Model: Model AR-P1	Date: 16-Feb-04	No.: MG081001a
--------------------	-----------------	----------------

MB Correction

Modified Article: Parts Catalog Corrections		Prepared by: K. Moriizumi	
From: 1st Tech. Support Sec. Service Support Dept.			
Reason for Modification:	<input checked="" type="checkbox"/> Parts catalog correction	<input type="checkbox"/> Vendor change	<input type="checkbox"/> To meet standards ()
	<input type="checkbox"/> To facilitate assembly	<input type="checkbox"/> To improve reliability	
	<input type="checkbox"/> Part standardization	<input type="checkbox"/> Other

Note 1:

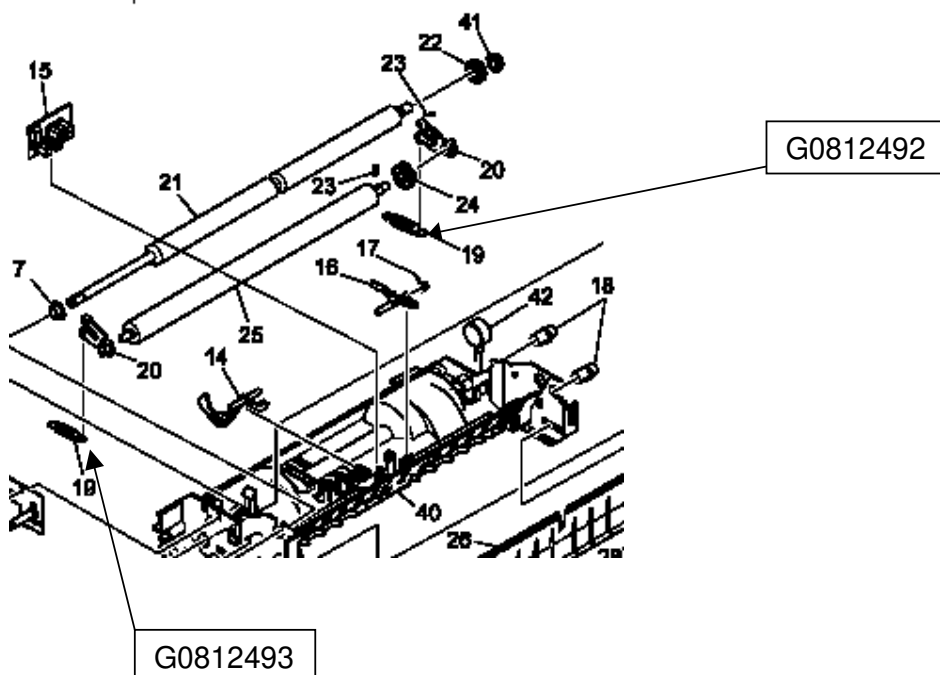
The springs (part number: G0812416, index 19) have been changed to G0812492 and G0812493 as follows.

Note 2:

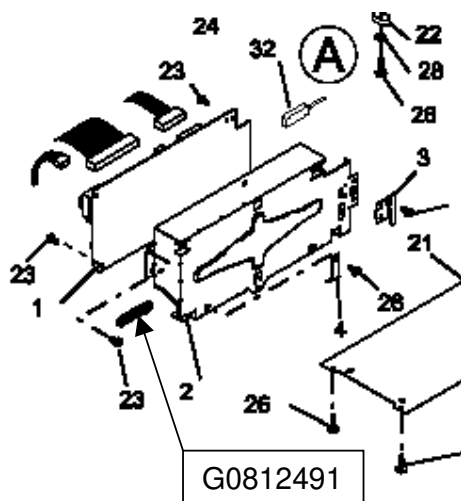
The Recovery Ground Plate (part number G0812491, index 40) has been added as follows.

Note 3:

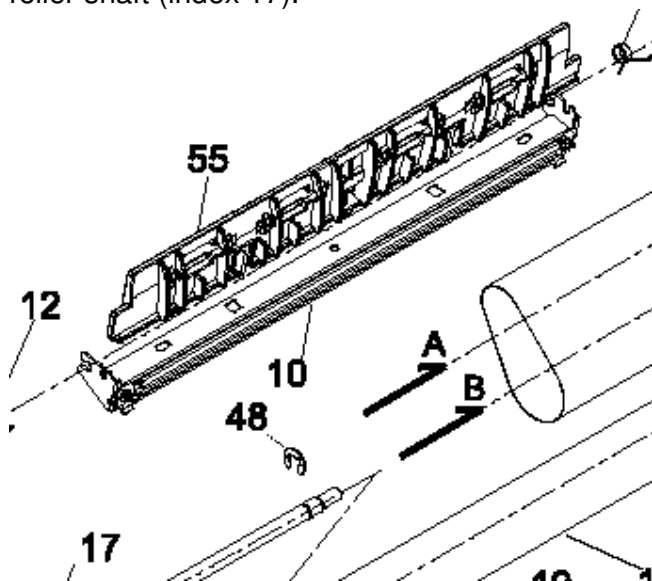
The separator holder (G0814048: index 56) has been combined with the paper separator (G0814010: index 10). Also, a G0814529 e-ring (index 48) has been added to the heat roller shaft (index 17).
